CHANGE ORDER NUMBER: 1

Project: 1804-222
Roadway: Pearson Ranch Road Signal
CSJ Number: _____

**Pearson Ranch Road Signal
Williamson County Project No. 1804-222**

Change Order No. 1

**ELECTRIC SERVICE
DELIVERY
DISTRIBUTION SERVICES**

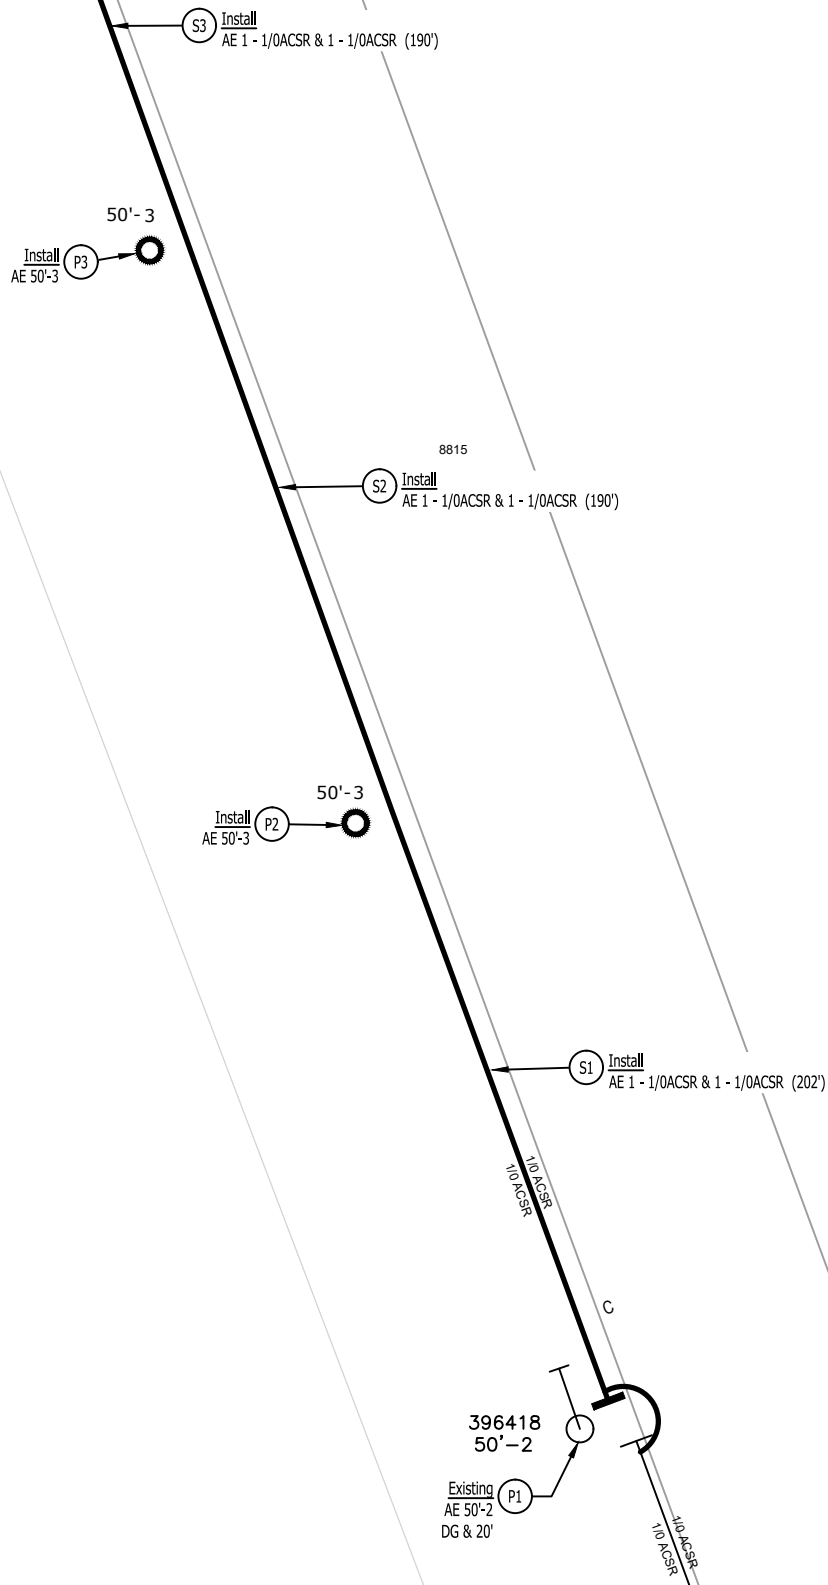
Austin Energy will perform work to include setting 3 new overhead poles and hanging a new overhead transformer to serve the traffic signal located at Pearson Ranch Rd & Neenah Ave associated with Work Request #185922.

1. Service shall be single-phase, three-wire, 120/240 volts only, in accordance with the City's Electric Utility Criteria Manual.
2. Austin Energy cannot energize any transformer until an easement has been signed by the property owner. The easement must cover all Austin Energy equipment. For additional information concerning easements, please contact David Lambert at 322-6109 and reference this Work Request #185922.

4. The customer service point will be the pull box housing service terminations. The customer's secondary must have a full current neutral. Austin Energy will furnish and install all wire and electrical equipment on Austin Energy's side of the customer's service point.
